Service Bulletin

Bulletin No.: 22-NA-057

Subject: Fuel Door Does Not Open, Fuel Door Tappet Falls Out of the Hinge

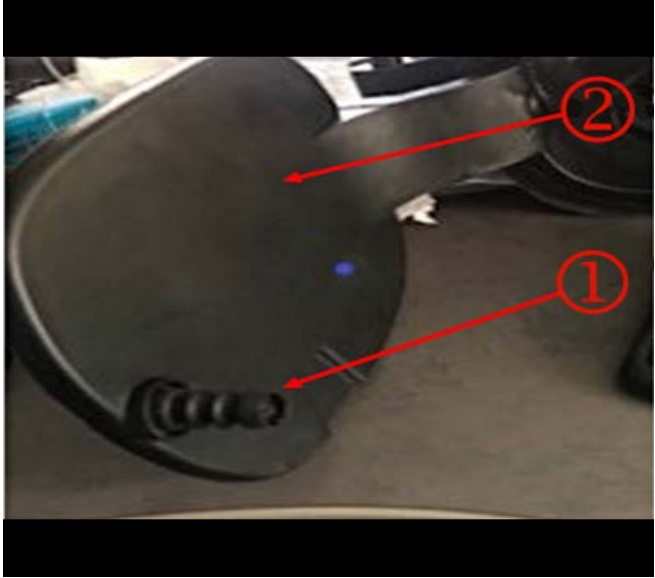
<p>Involved Region or Country</p>	<p>North America</p>
<p>Condition</p>	<p>Some customers may comment on having one of the following conditions:</p> <ul style="list-style-type: none"> • Fuel door does not open • Fuel door tappet falls out of the hinge
<p>Cause</p>	<div style="text-align: right; margin-bottom: 10px;">6003725</div>  <div style="text-align: right; margin-bottom: 10px;">6014256</div>  <p>This condition may be caused by the tappet, as shown in the picture above (tappet and rubber boot) (1), becomes detached making the tappet loose in the housing hinge (2) misaligning the tappet to the lock actuator or the tappet is no longer retained to the hinge (missing tappet). The misalignment of the tappet to the lock actuator could cause the fuel door to not operate correctly and in some cases damage the lock actuator or lock actuator mount (3), shown in the picture above. A missing tappet boot may also cause the tappet to become detached to the hinge as the boot is part of the secure attachment of the tappet to the hinge.</p>

<p>Correction</p>	<p>If the tappet or boot is missing, replace the tappet following the procedure below. Note: Replace the fuel door if it is damaged, new fuel door comes with the tappet.</p>

1. Remove the tappet, turn clockwise ¼ turn and discard.
2. Align the new tappet base tabs to the hinge opening and turn counter clockwise ¼ turn, making sure the tappet boot is correctly positioned and

Note: The new tappet should NOT have any movement in any direction.
